Re: **Docket No. 535 – The Towers, LLC application for a Certificate of Environmental Compatibility and Public Need for the construction, maintenance and operation of a telecommunications facility and associated equipment located at 835 Norwich Worcester Turnpike (Route 169) in Woodstock, Connecticut**

RESPONSES OF THE TOWERS, LLC TO  
INTERROGATORIES FROM INTERVENOR PASKA NAYDEN

**Existing Verizon Wireless 5G Coverage**  
**Woodstock, Connecticut and Surrounding Area**  
 (\*Map Scale is 1:28,000)

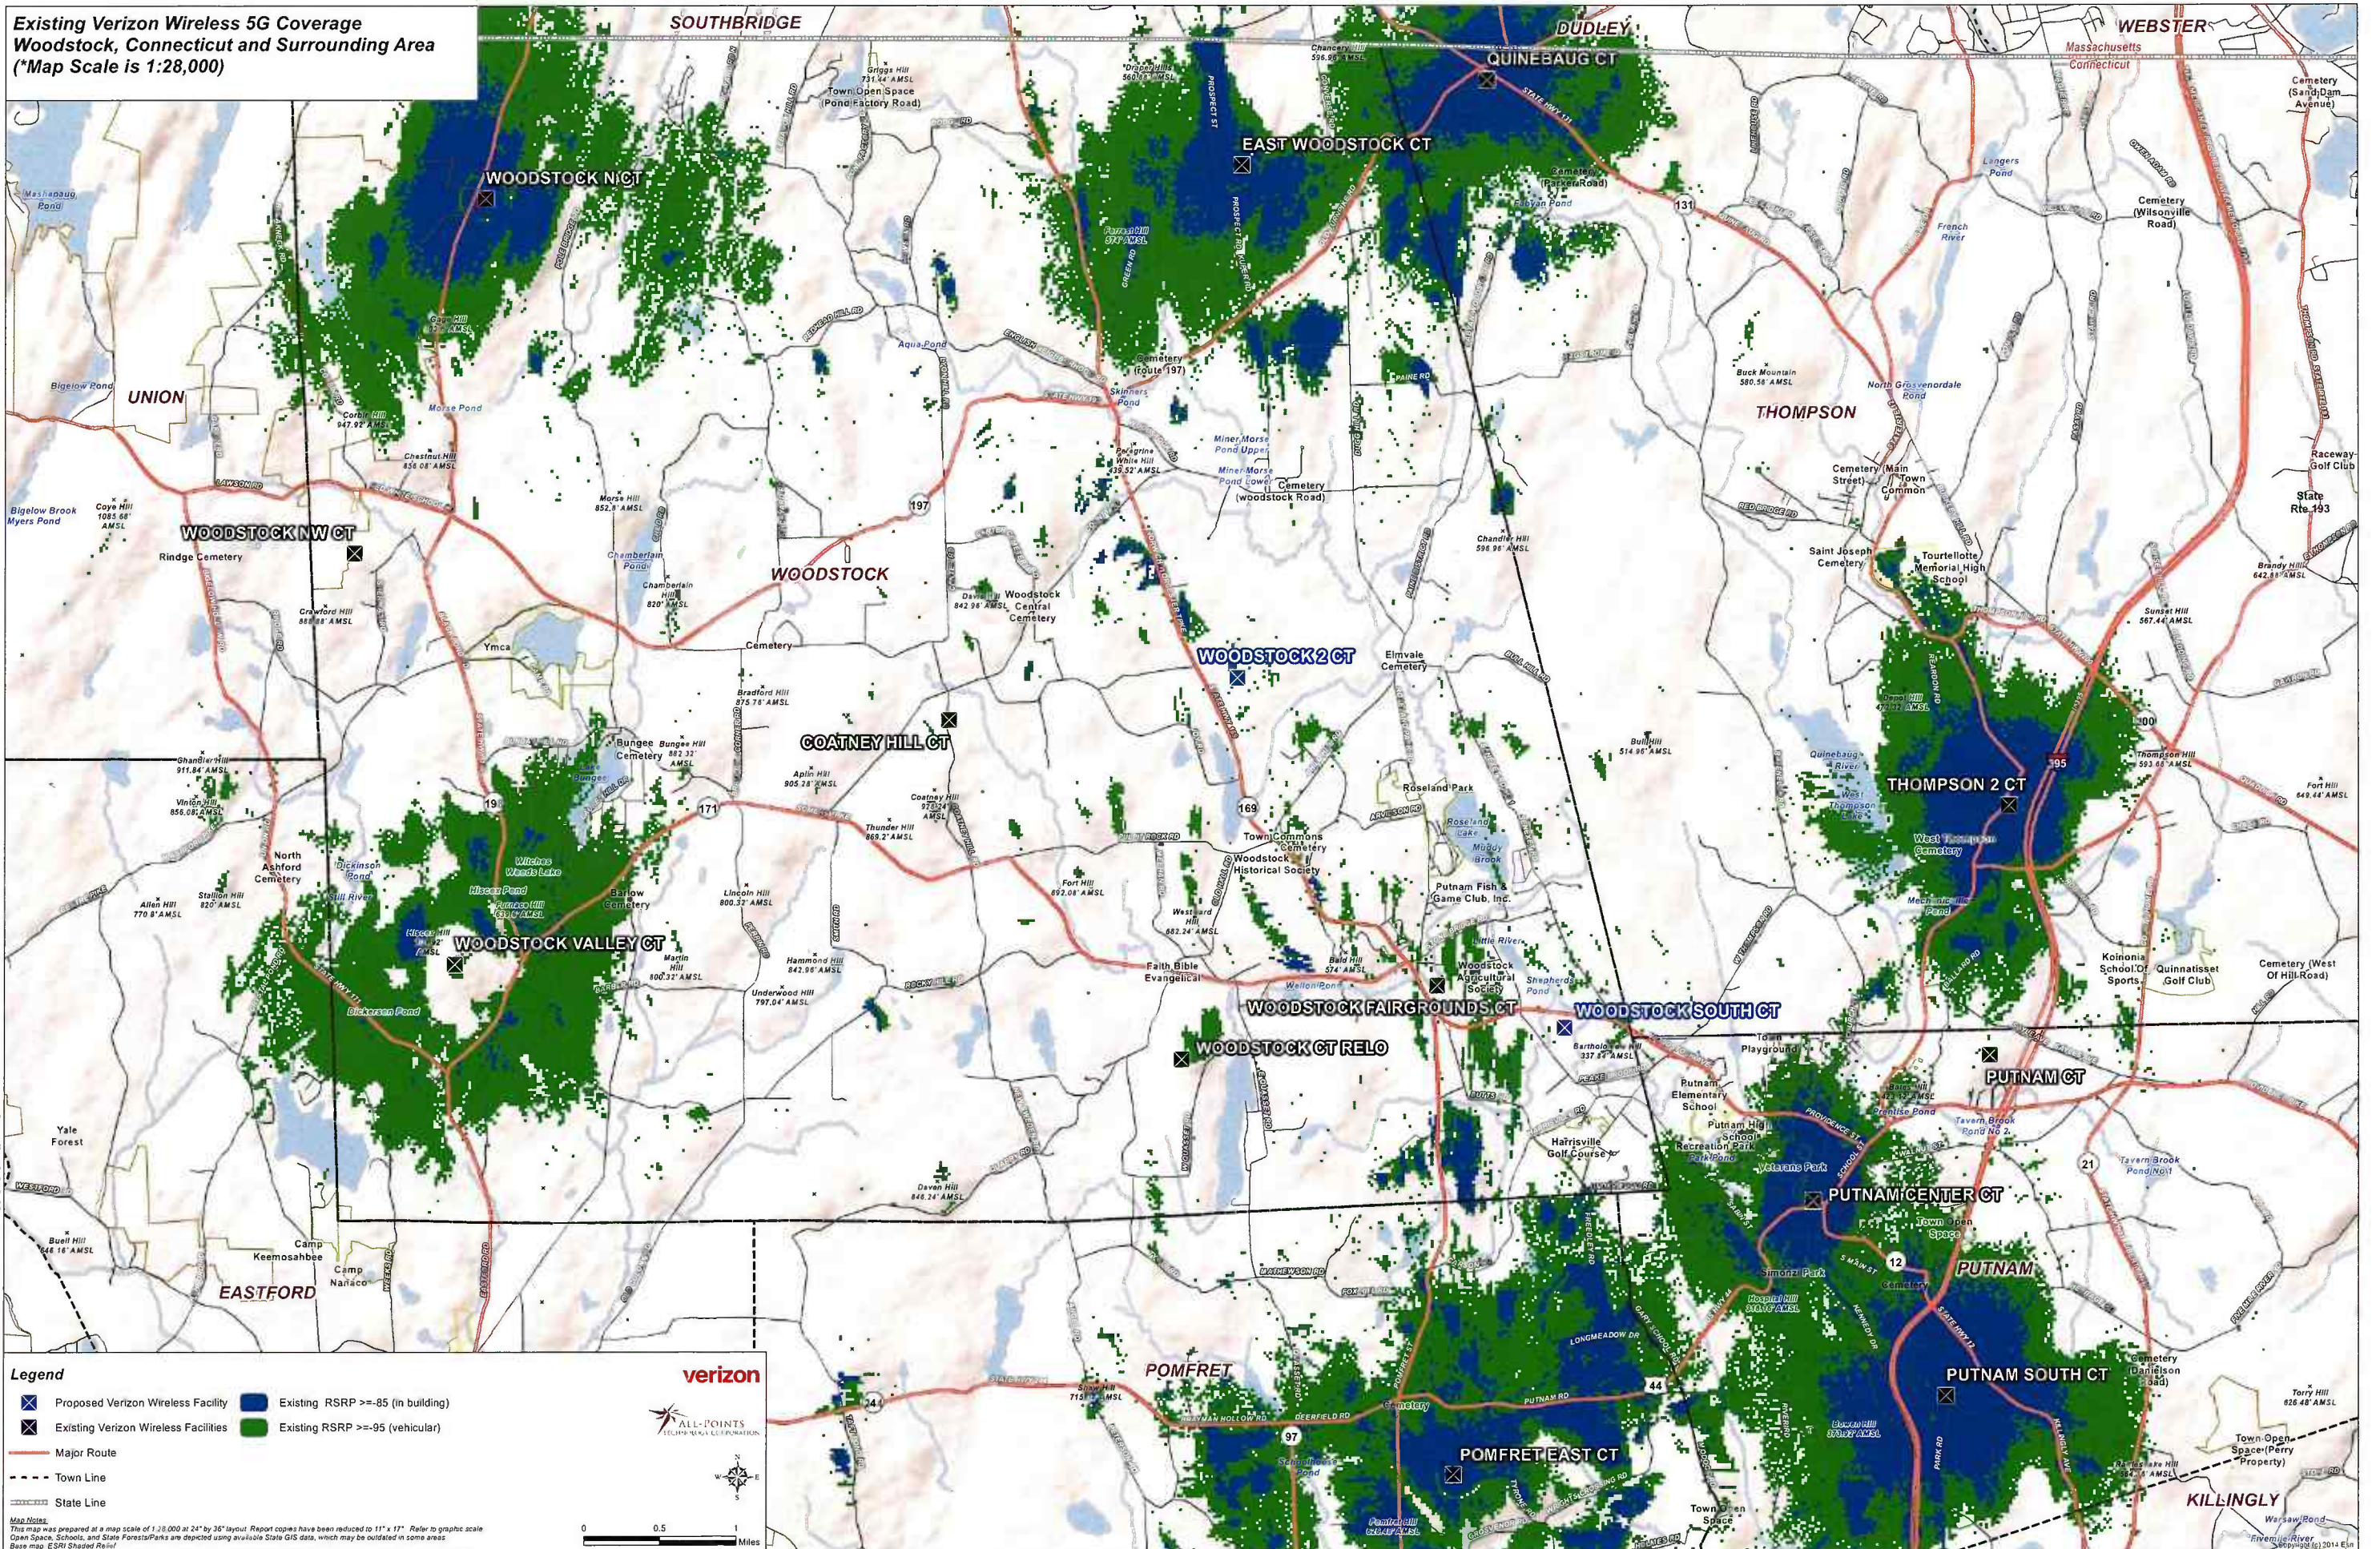
Provide side-by-side RF scenarios: (A) Docket 535 only, (B) sister site only (Docket 534), and (C) both sites together, with population/road-mile gains and any remaining gap.

As described in the Applicant's response to Council Interrogatory No. 22, the facility proposed and currently under Council consideration in Docket No. 534 (Cellco's Woodstock South Facility) is 3.2 miles southeast of the Woodstock 2 Facility (Docket No. 535). Coverage from the two sites would overlap to allow for call/service hand-off. Coverage plots showing Cellco's wireless service from both the Woodstock 2 and Woodstock South facilities are attached as Exhibit 1 to these responses.
